**CITY OF LAKE GENEVA**  
**PLAN COMMISSION MEETING**  
MONDAY, OCTOBER 19, 2015- 6:30 PM  
COUNCIL CHAMBERS, CITY HALL

**Subject:** Review of Certified Survey Map and Site Plans by Key Development Partners, LLC (for Home Depot USA Inc.) in the City of Lake Geneva

We have completed a review of a Certified Survey Map prepared by Stephen R. Krueger of Woolpert and site plans drawings including General Development Plans (PD/GDP) dated September 2015. The CSM review was conducted to determine compliance with Chapter 236 of the Wisconsin State Statutes, Chapter 66-36 of the City of Lake Geneva Municipal Code and good surveying practices. The Certified Survey Map dated September 24, 2015 was reviewed. The Engineering review was conducted to determine compliance with the City of Lake Geneva Municipal Code and good engineering practices.

# CERTIFIED SURVEY MAP NO. \_\_\_\_\_

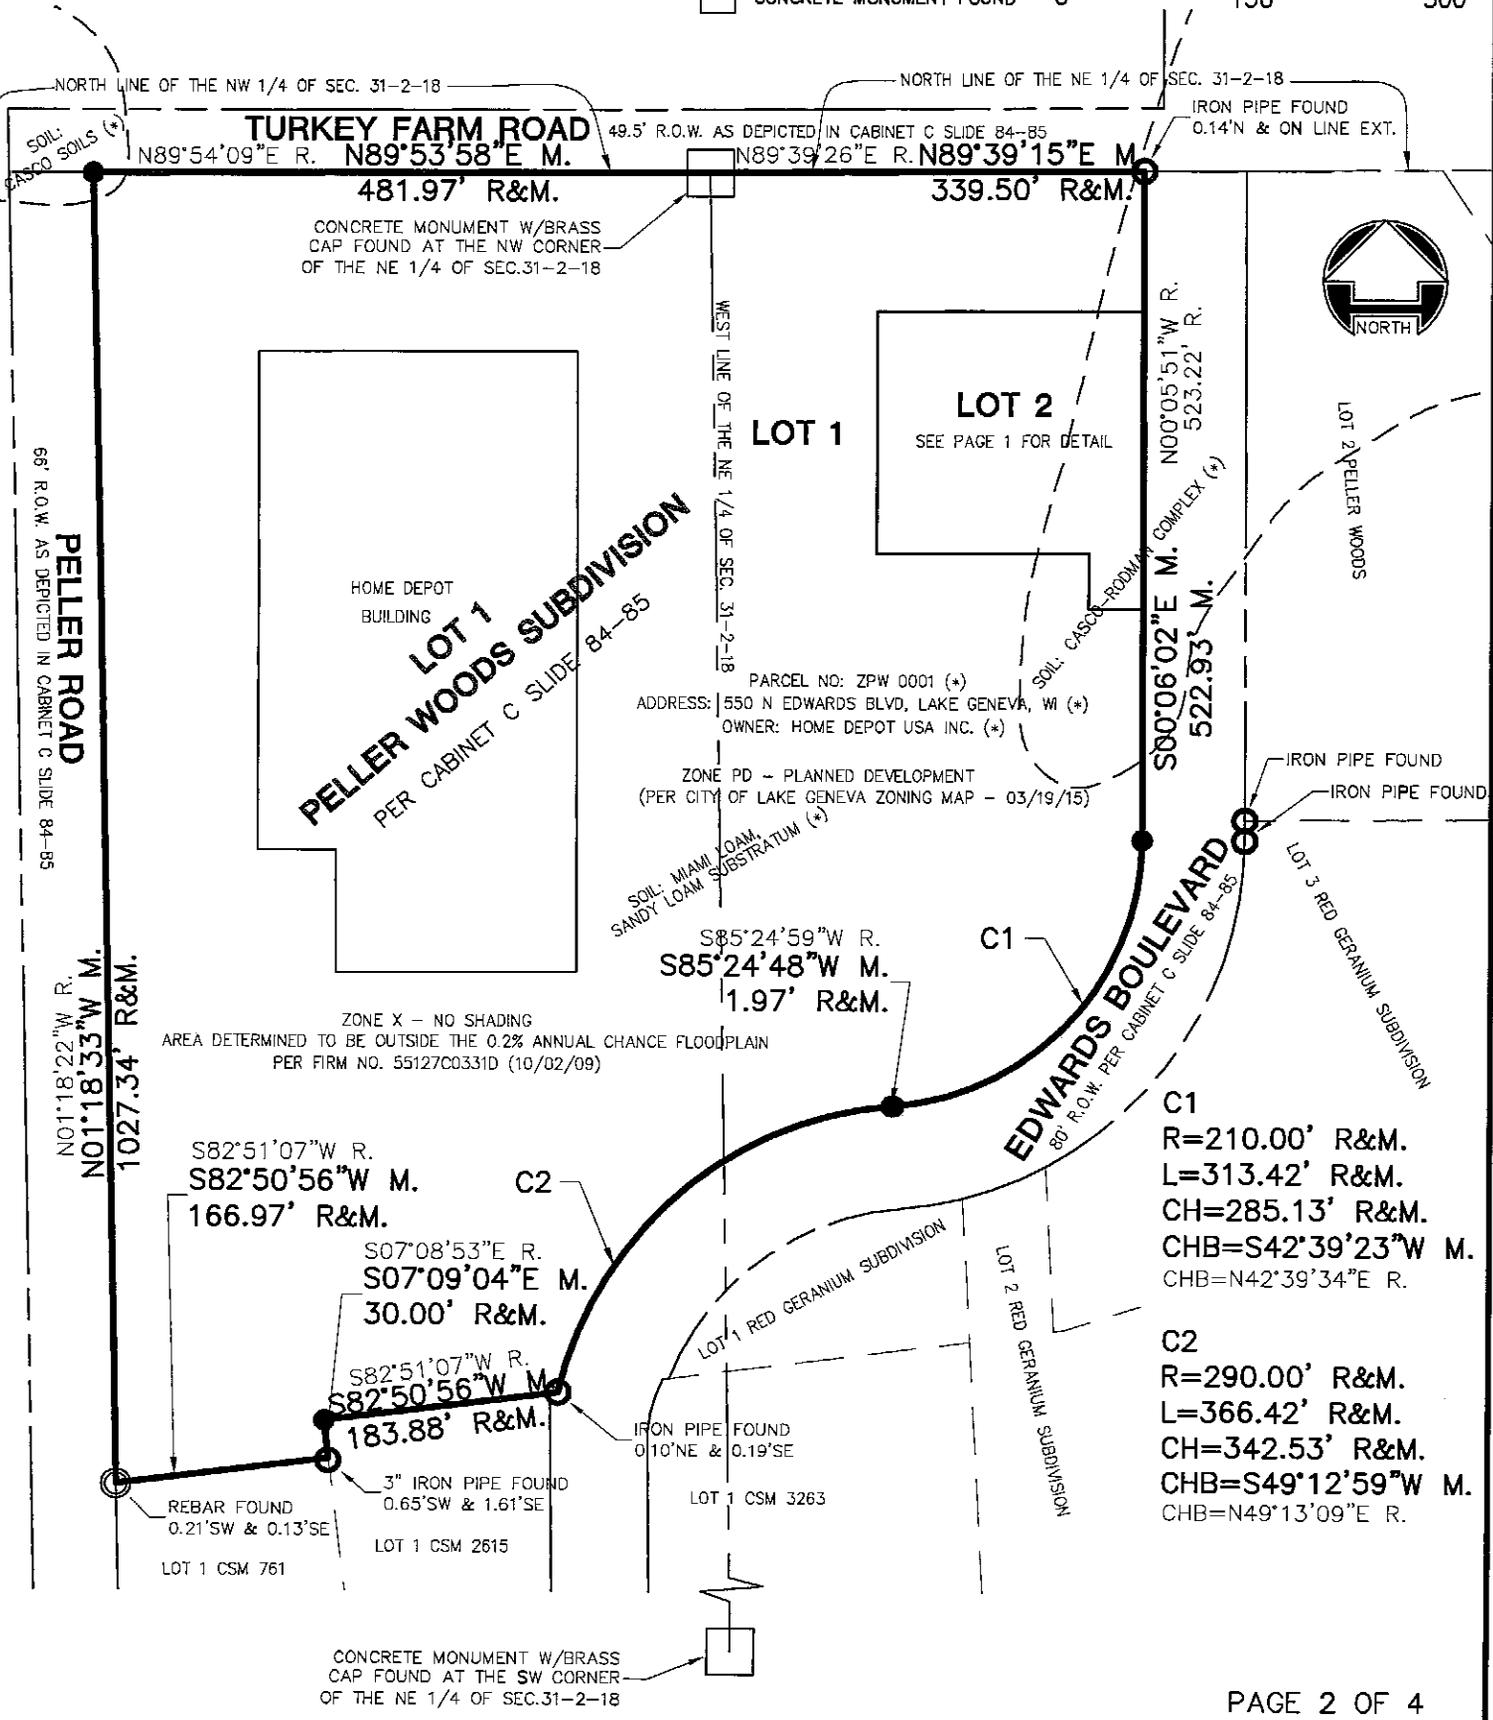
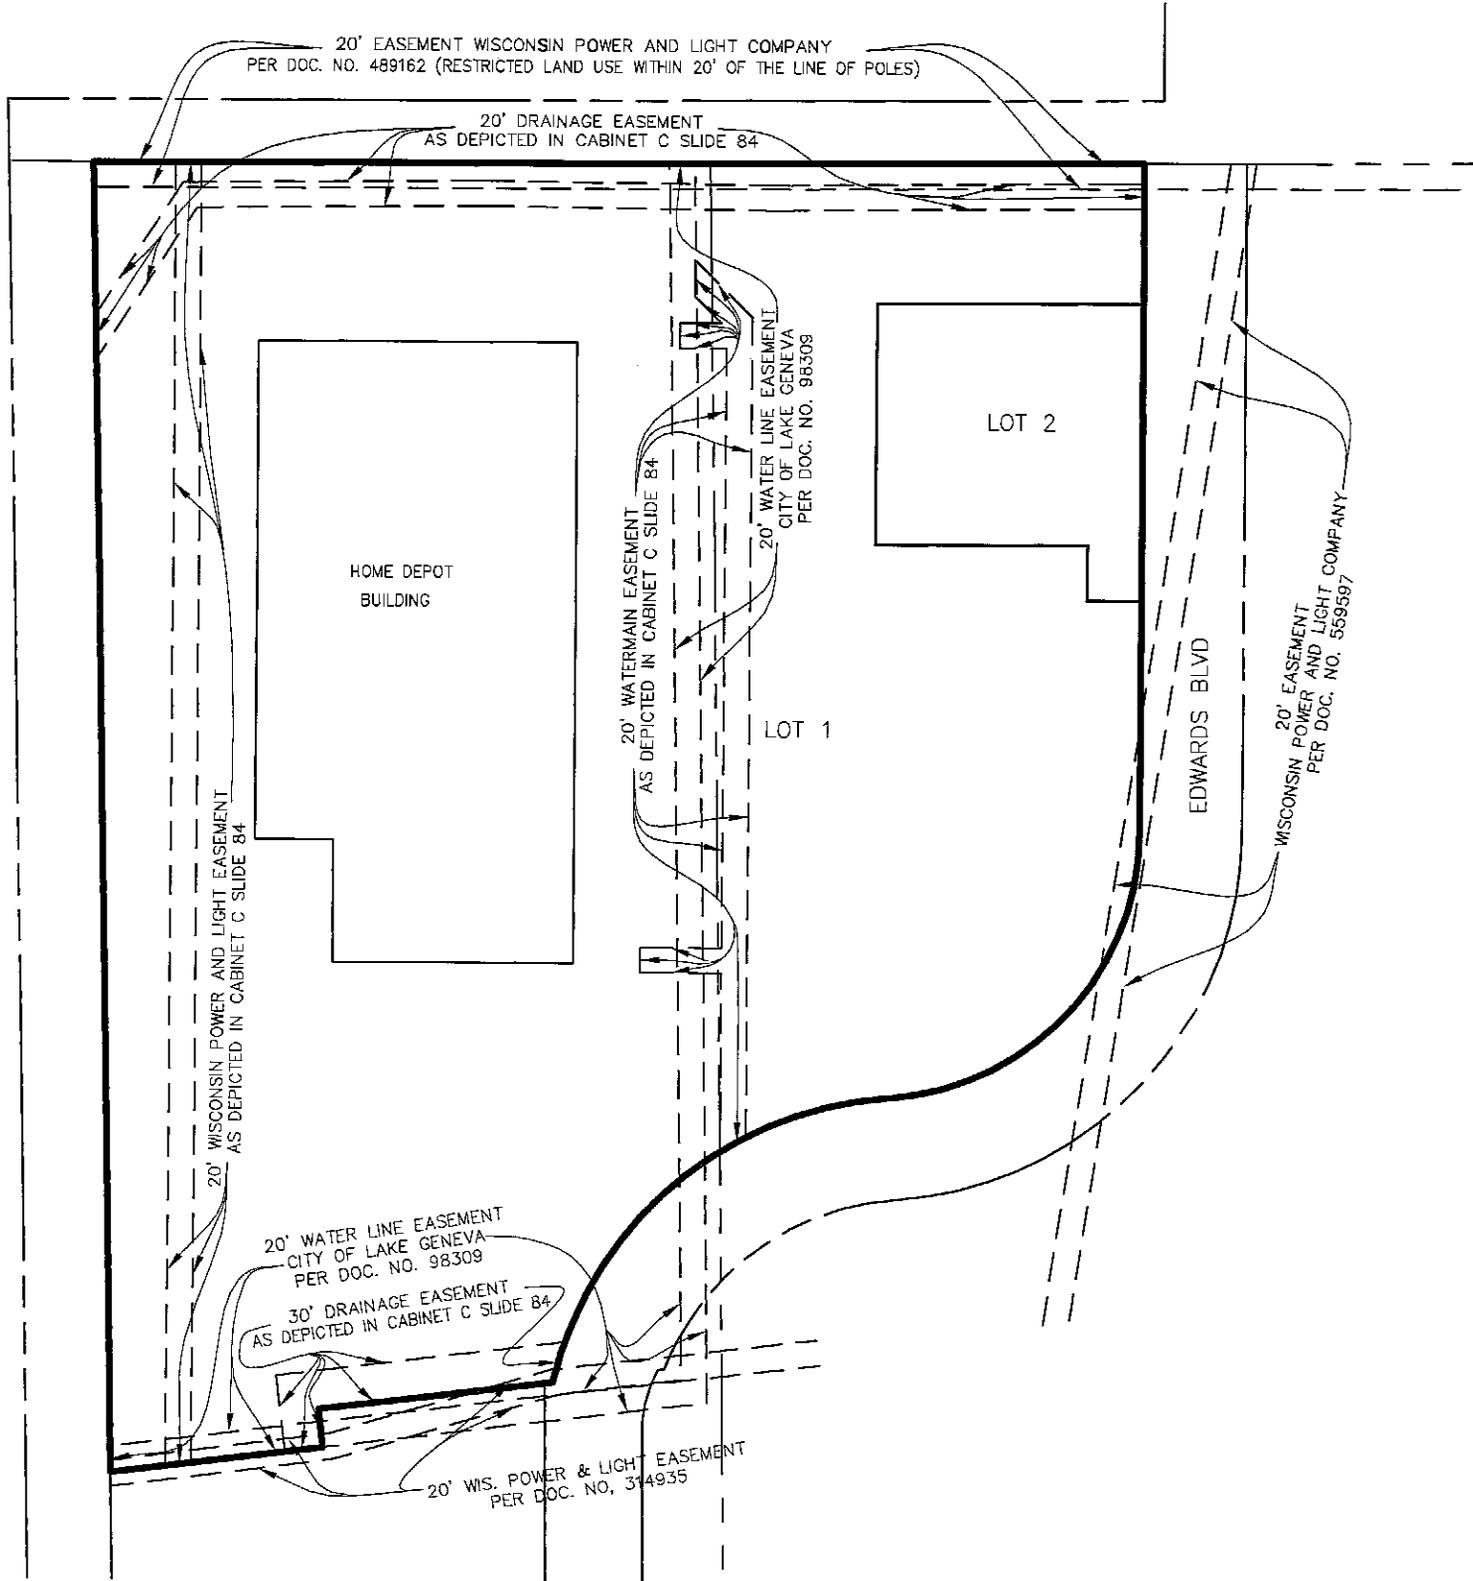
- As per s.236.20 (2(b)) - Please indicate the outside diameter of all monuments.
- As per s.236.20 (3(d)) - Please underscore adjoining street and subdivisions with dashes or dots.
- As per s.236.20 (2(k)) - Please indicate the central angle subtended and tangent bearings for each of the curves.
- As per s.236.34 (1(d(3))) - Please revise the Surveyors Certificate to include "and dedicated" if this is warranted in the addition of right of way on Turkey Farm Road.
- As per s.236.34 (ar) - Please remove the Department of Administration and Walworth County Planning from the Owner's Certificate.
- As per sec. 66-36(1) – Please remove the City Council Resolution Certificate show only the Plan Commission Approval Certificate with the City Clerk Resolution note.

SHEET NO. **C200**

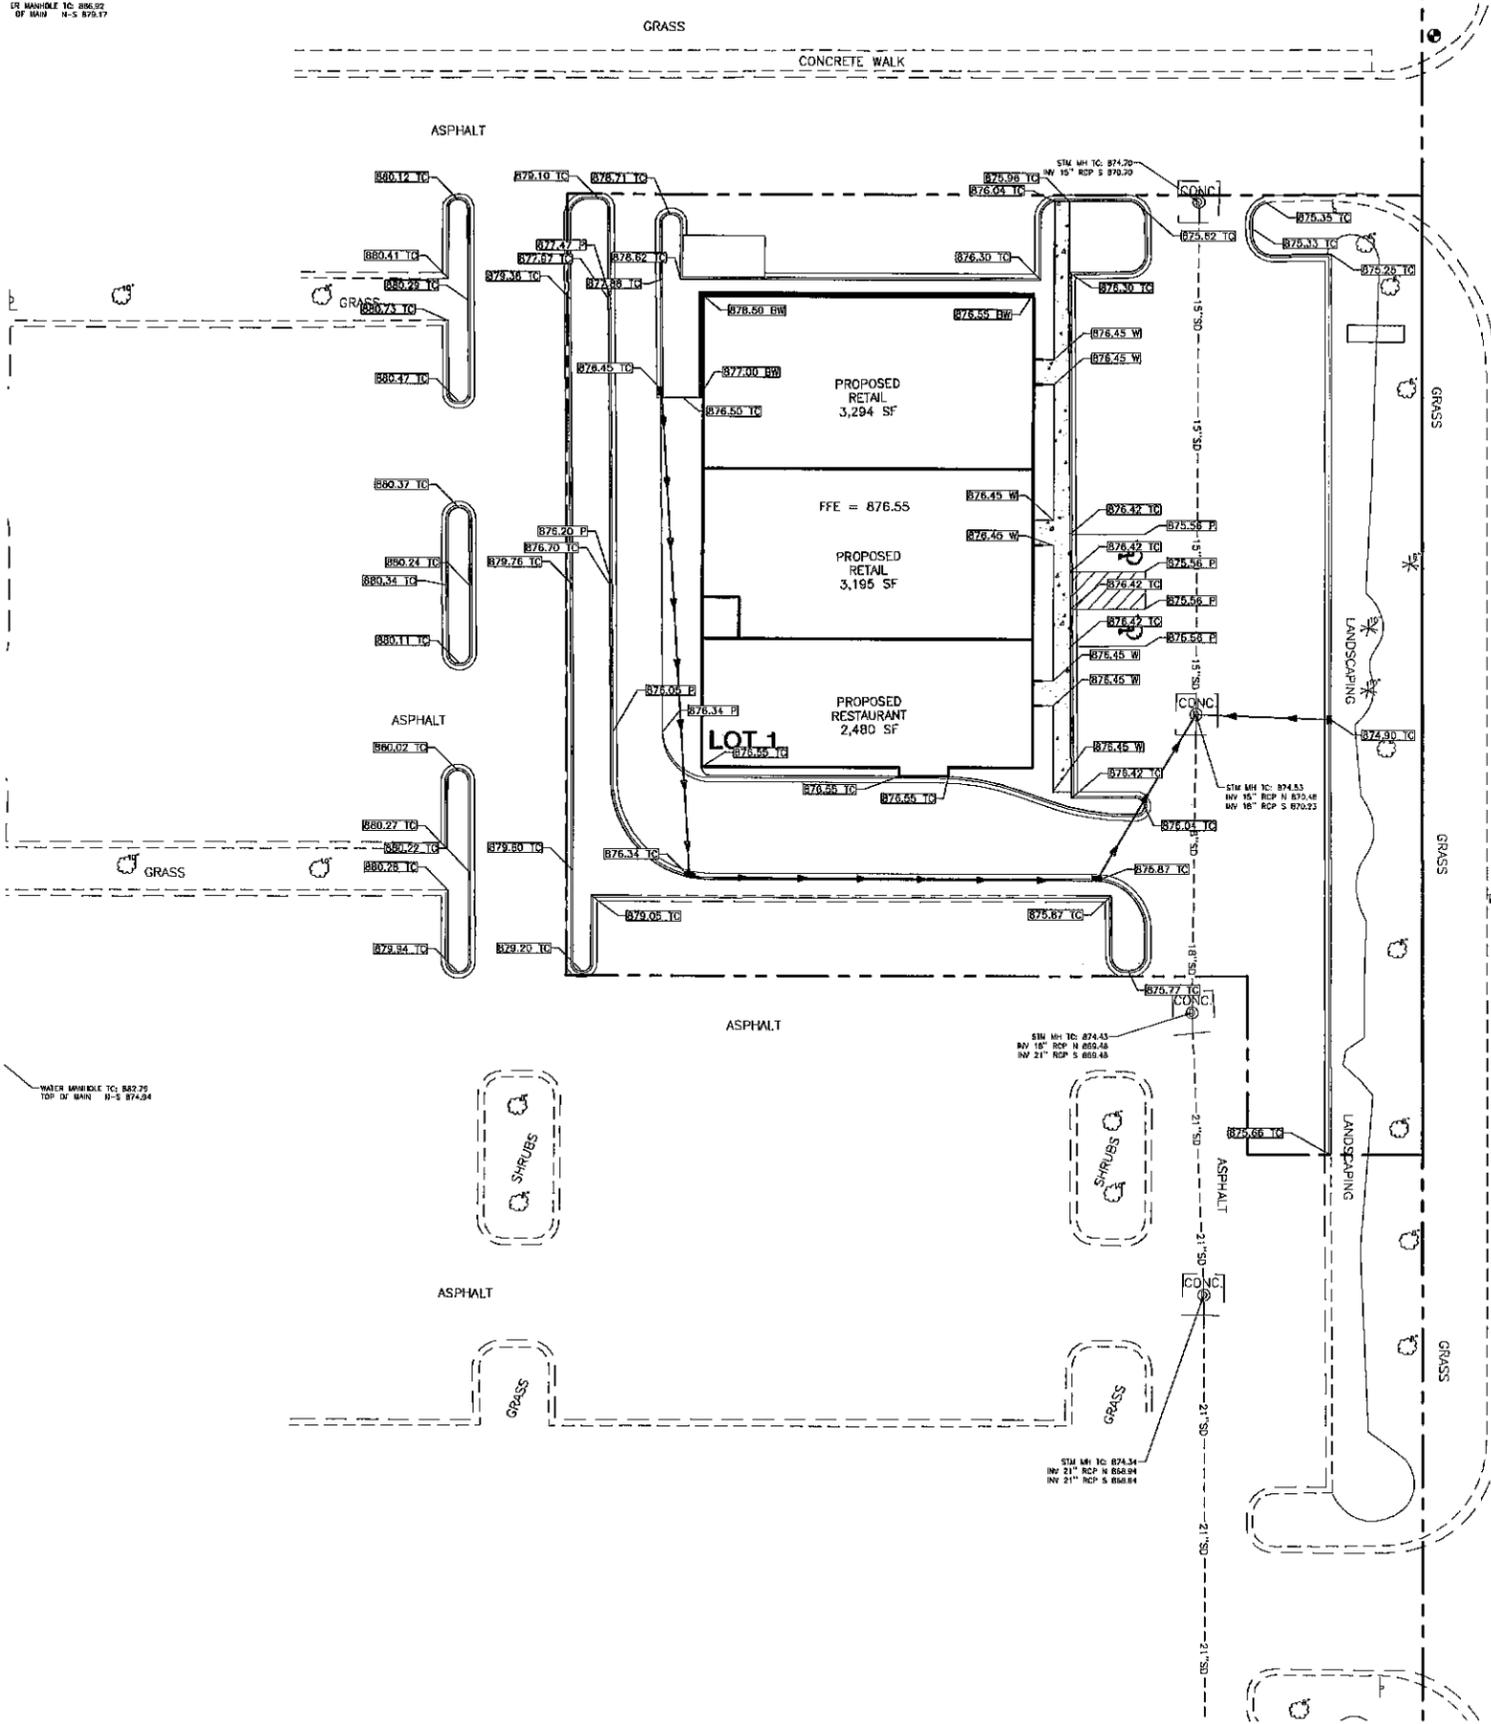
- Many of the site notes on Sheets C200 and C300 refer to the Illinois Department of Transportation Specifications (IDOT). All reference in the notes shall refer to Lake Geneva and Wisconsin Department of Transportation Standards and specifications. (WisDOT). Specifically, Items 3, 4, and 8 on sheet C200 and Items 5, 24, and 31 on Sheet C300.

- Many of the Site notes are not applicable to this project, please review all site notes and remove any items not specific to the proposed improvements. It appears that notes 10,11,12, possibly 20,27,28,29 and 31 do not apply.

- Protective bollards have not been shown on the site plan. They may need to be considered at the drive through window area and southwest corner of the building.

- Update the site legend to reflect current project applicability requirements and detail call outs.
- A 6" Water main is shown entering the service room somewhere from the west. Please provide detail in the PIP submittal. Trench work and restoration associated with the installation of the new water main service shall be shown on the plans.

- The Final grading plan shall detail the accessible ramps and associated grades. WisDOT standards ramps types shall be followed.

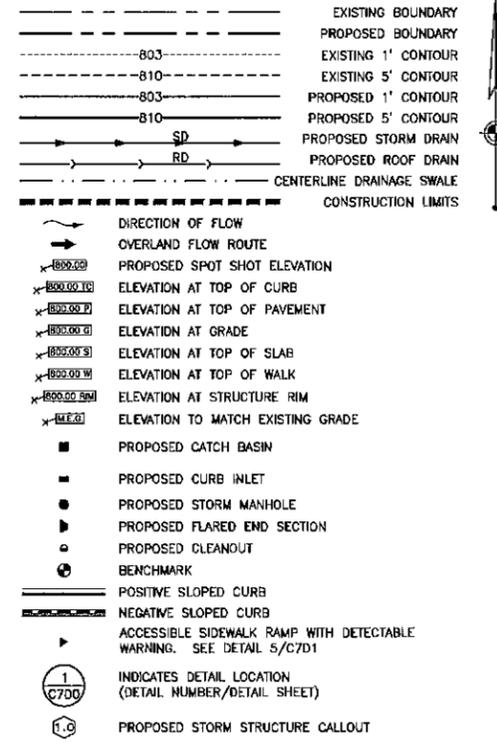
- Please confirm that the existing light pole in the northeast island is being removed. Trench work and restoration associated with the installation of the new lighting shall be shown on the plans.
